Record of Decision
Ley Creek PCB Dredgings Site
Salina (T), Onondaga County
Site Number 7-34-044

DECLARATION STATEMENT - RECORD OF DECISION

**Ley Creek PCB Dredgings Site
Proposed Remedial Action Plan
Salina(T), Onondaga County
Site No. 7-34-044**

LEY CREEK PCB DREDGINGS		
NYSDEC SITE No. 7-34-044		
DIVISION OF ENVIRONMENTAL REMEDIATION		
REVISION:	DRAWN FROM O'BRIEN AND GERE LEY CREEK BASE MAP	
DATE: 9/27/96	DRAWING:	
FIGURE 2: PROPOSED EXCAVATION AND CONSOLIDATION AREAS

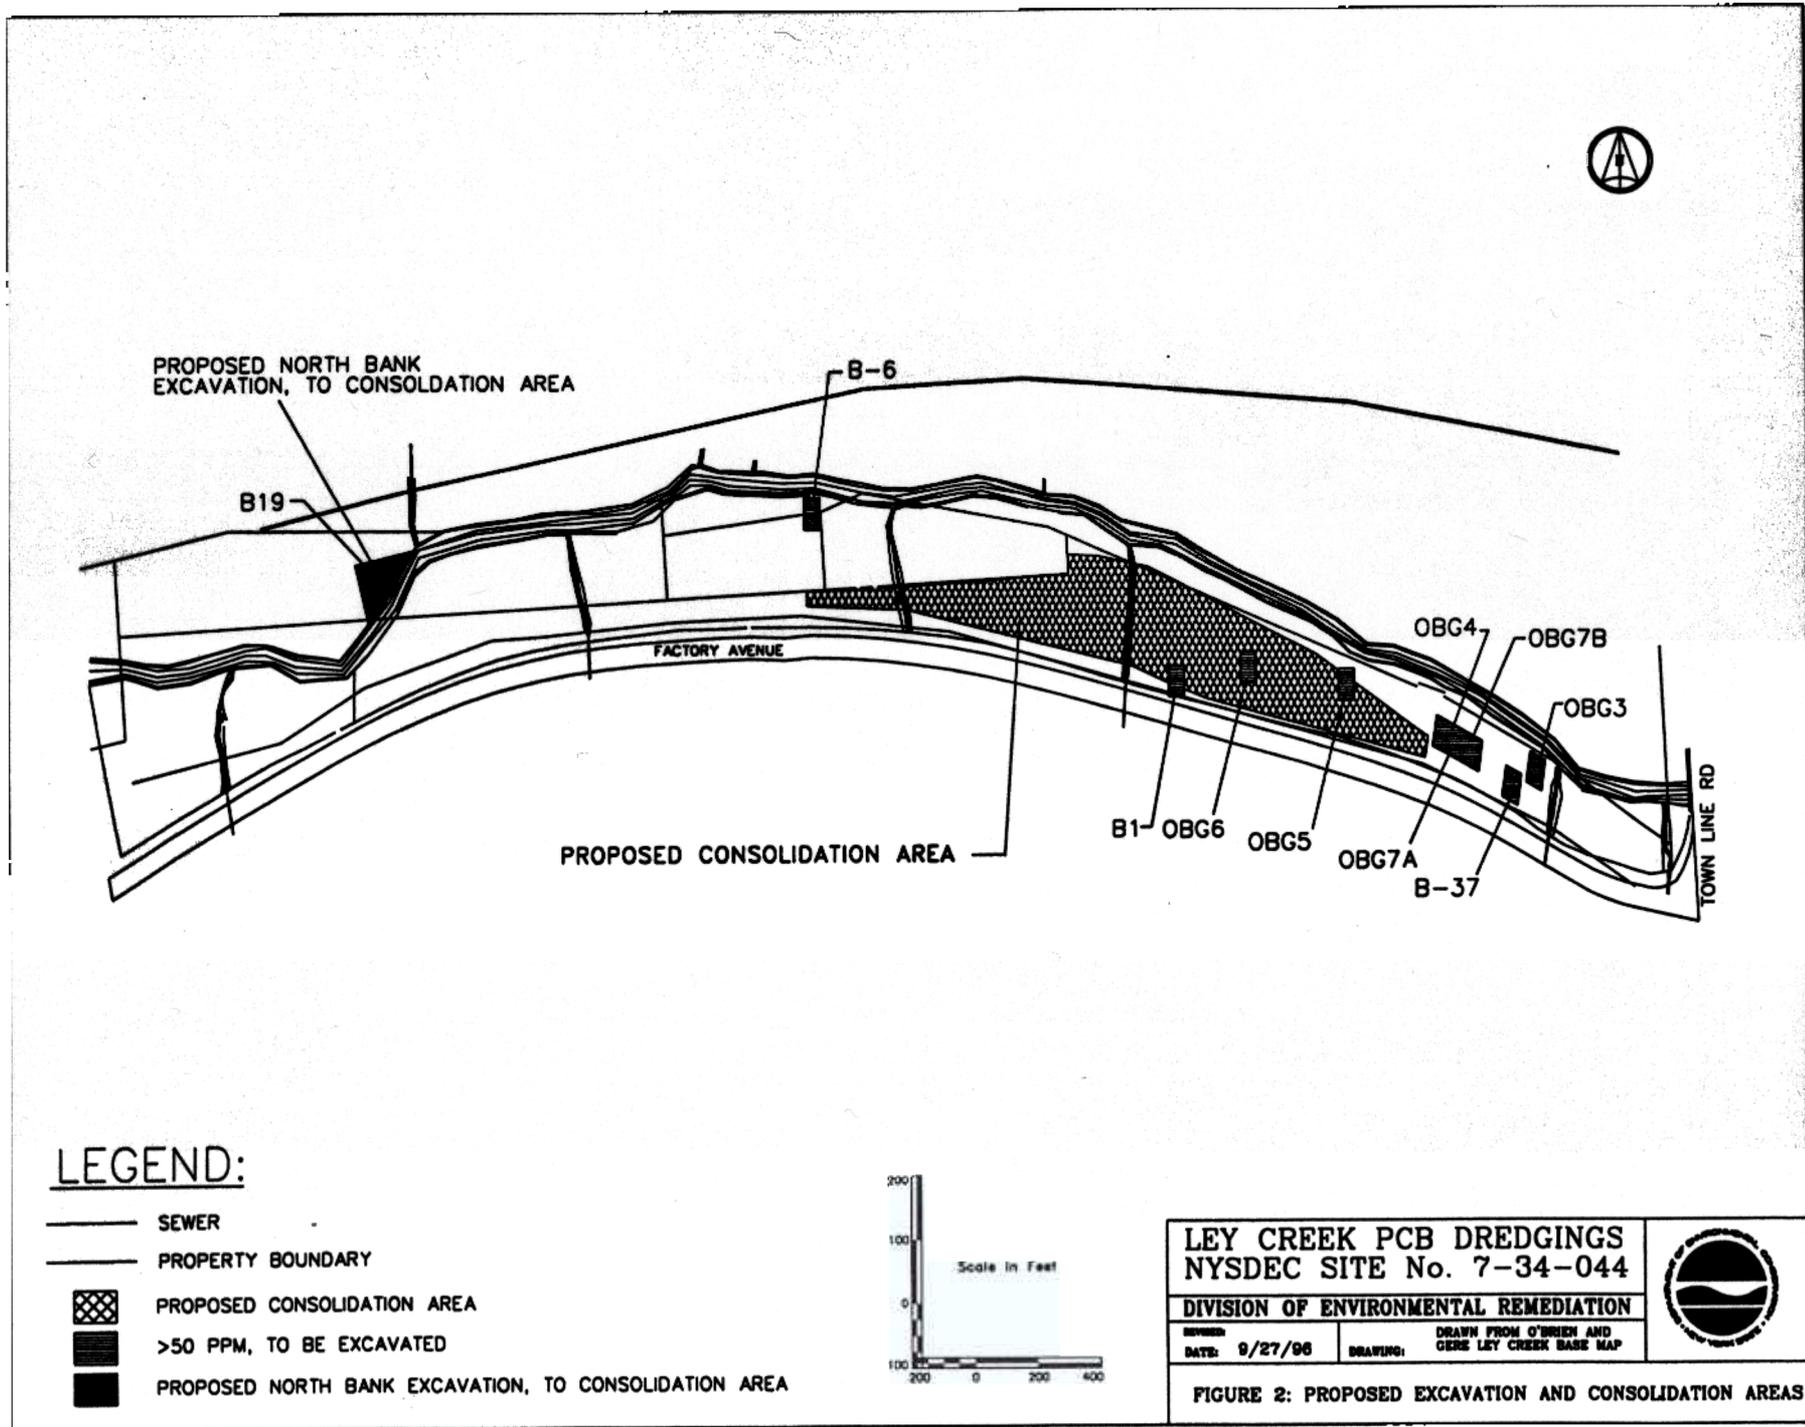
COMMENT 14: Alternative 8 contemplates, in part, removal and off-site disposal of soil taken from certain "hot spot" areas (Final Feasibility Study, dated October 1996, "Final FS", p 59). However, the "hot spot" areas may not be the only areas of significant PCB contamination.

According to the map entitled Proposed Excavation and Consolidation Areas (Final FS, Figure 10), none of the "hot spot" areas to be excavated appear to be located on the Ryacuss parcel. However, the closest excavation point seems to be less than 200 feet away (Id.). The maps containing the soil boring locations included with the appendices of the Remedial Investigation Report ("RI") and the Final FS do not delineate the boundary of the Ryacuss parcel making it difficult to determine soil boring locations in relation to the Ryacuss property boundary.

It is possible that either or both soil borings designated as B7 and BB lie within the Ryacuss property boundary (Final FS, Figure 2).

RESPONSE 14: The location of all soil borings have been reviewed relative to the Ryacuss parcel. After the reviewing the RI data in response to this comment it was identified that the location identified in the Feasibility Study and the PRAP as boring location B-6 was in fact boring location B-6M. The actual location of B-6 is near the northeast corner of the Ryacuss parcel. The correct location of boring B-6 is shown on a revised Figure 2 in the ROD.

FIGURE 4: PROPOSED FLOODWAY REMEDIATION PLAN

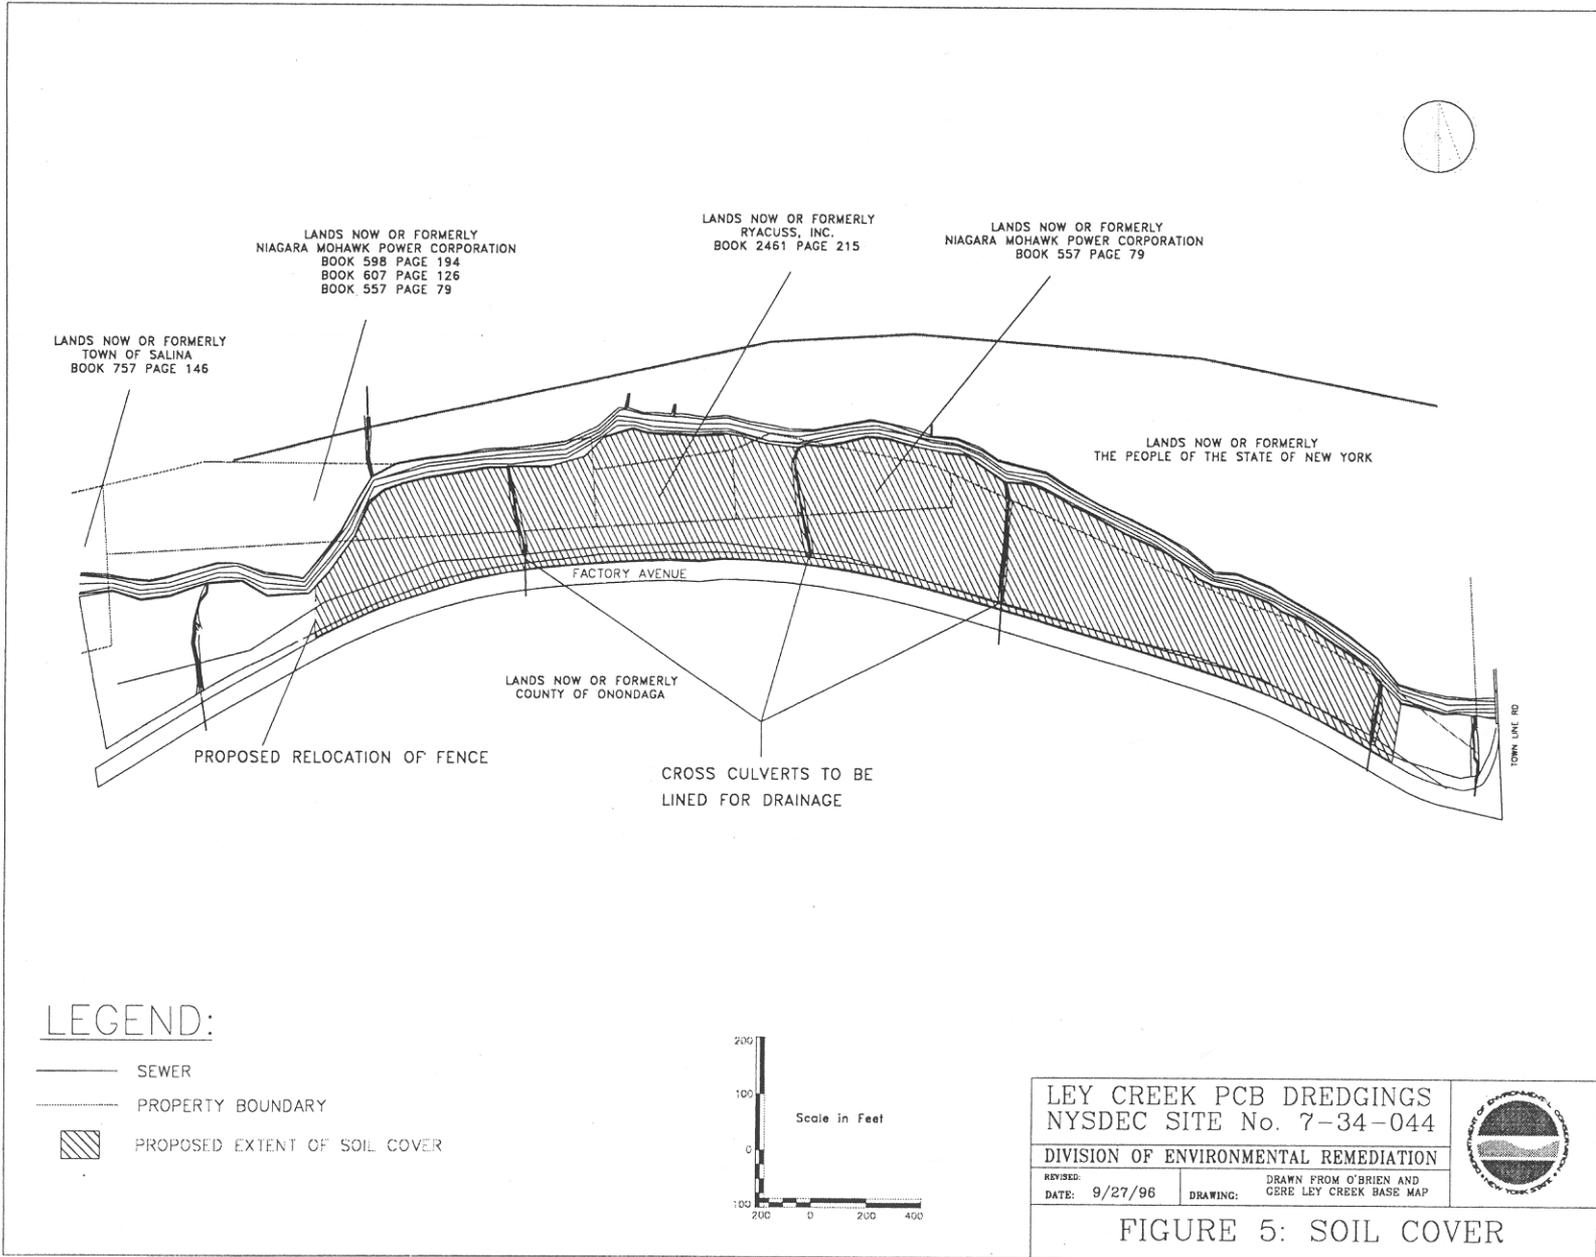
COMMENT 18: The PRAP does not indicate the appropriate elevations to which the dredgings will be placed. This issue was addressed in a letter prepared by General Motors' counsel dated August 30, 1995. In that letter a portion of the remedial plan is described as the moving and regrading of the dredgings away from the " ... first 25 feet of floodway south of Ley Creek to create elevations of 370 feet or less ... ".

We assume that the term "floodway", as it is used in the Final FS, means that portion of the 100 year flood plain as identified on the 1982 Federal Emergency Management Agency Flood Boundary and Floodway Map provided as Exhibit C of the Final FS. The floodway appears to be an estimate of some sort (Final FS, Figure 8 which shows the "approximate floodway" 11 ... plotted from 1982 [FEMAI flood boundary and floodway map]).

RESPONSE 18: The ROD has been revised to reference the floodway area as defined by the above referenced FEMA mapping. A specified elevation is not generated in the definition of the map of the floodway, as is the case when defining the 100 and 500 year flood events. The assumption regarding the term floodway is correct and the area in question is as defined on the map.
